**REMARKS/ARGUMENTS**

**AMENDMENT TO THE DRAWINGS**

FIG.6

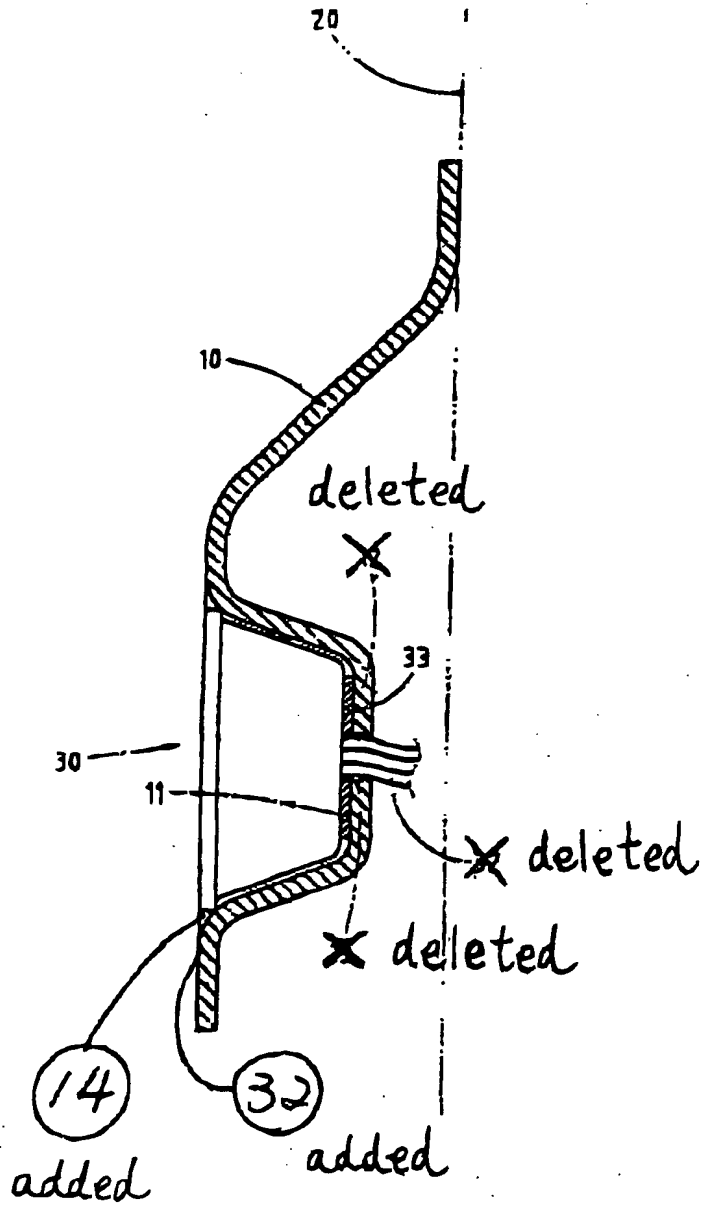
The drawings were originally objected to because Figures 5 and 6 do not match.

Replacement sheet is enclosed for the Examiner's approval. The attached sheet includes changes to Fig. 6. This replacement sheet replaces the original sheet. In figure 6, previously omitted element 14 has been added, and original elements 12 and 13 have been deleted. Besides, the position of element 32 has been corrected to pass through element 14. Besides, the bottom wall of element 11 has been corrected to have a closed shape. Besides, the wall of element 33 has been corrected to have a closed shape.

Responsive to this, Figure 6 is corrected to match Figure 5 in accordance with the Examiner's instruction and suggestion, and it is believed that the objection should be removed.
